Wake Stone Mining Permit 92-10 and its impacts William B Umstead State Park and on Protected Buffers required by the Permit

Buffers have been violated and DEQ has not taken action to require Mitigation, despite repeated complaints - significant adverse effects have now crossed over from the Buffers into William B Umstead State Park
The result is flooded parkland and dead mature trees

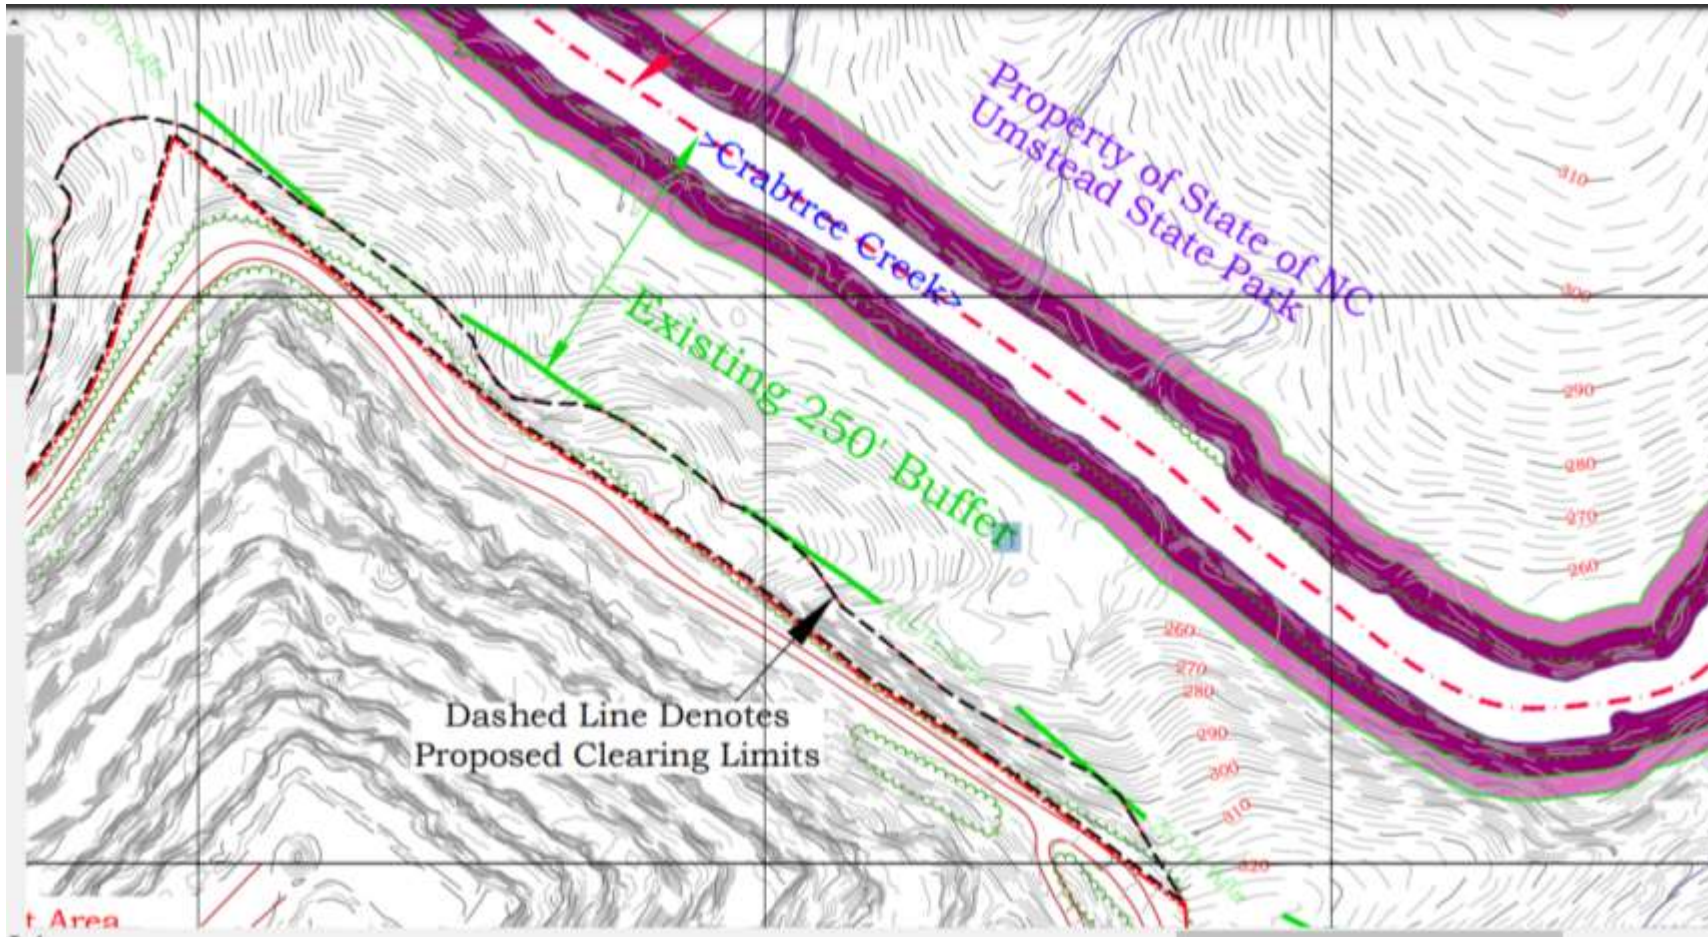
January 2021 Site Plan change proposed by Wake Stone undermines the 1981 Required buffer of existing natural vegetation from top edge of bank, gutting the protection to just the Neuse River Rules, and allows crossing the buffer and creek to establish haul road and bridge through the former Undisturbed buffer of Existing natural Vegetation.

Here on the existing site Wake Stone proposes changing Undisturbed Buffer of existing Natural Vegetation to just Buffer?? So much for honoring the 1981 Permit. Note they also have moved the buffer to Center of creek, allowing them to expand the pit closer to the park and the stream. In 2018 Permit modification approved in 23 minutes they removed Buffer text from the Permit and allowed them to control it on the site plan subject to state approval of the site plan.

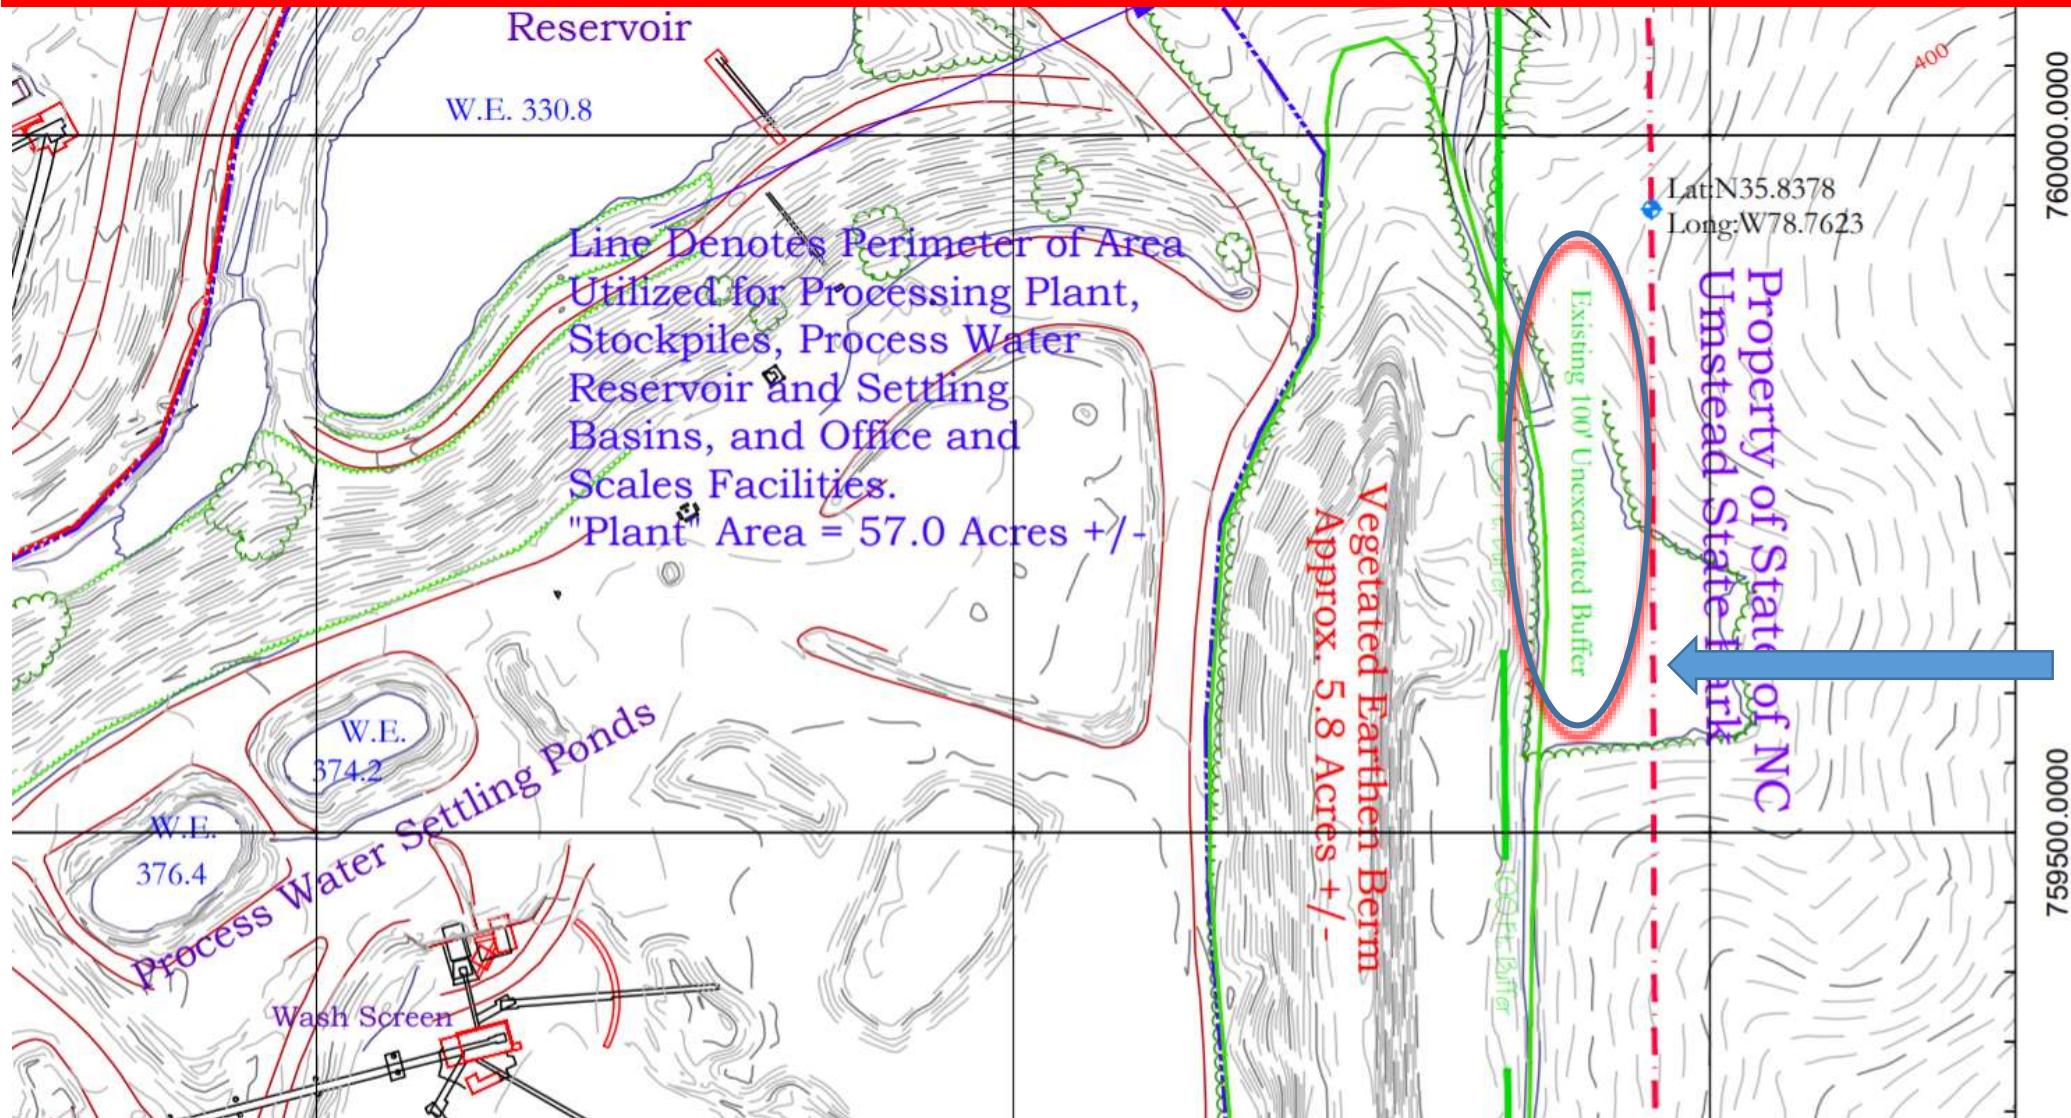
What has always been Undisturbed natural buffer of existing natural Vegetation from top pf bank in the permit is now proposed 1/2021 as just Buffer from center of stream.

could be **CLEARCUT** or **FLOODED**.

January 2021- Wake Stone now Proposes to downgrade the Undisturbed Natural vegetated buffer to simply UNEXCAVATED to cover up the flooding violation they have allowed. To do this they have requested the permit text be removed to allow the site plan they control and the state approved to allow these downgrades
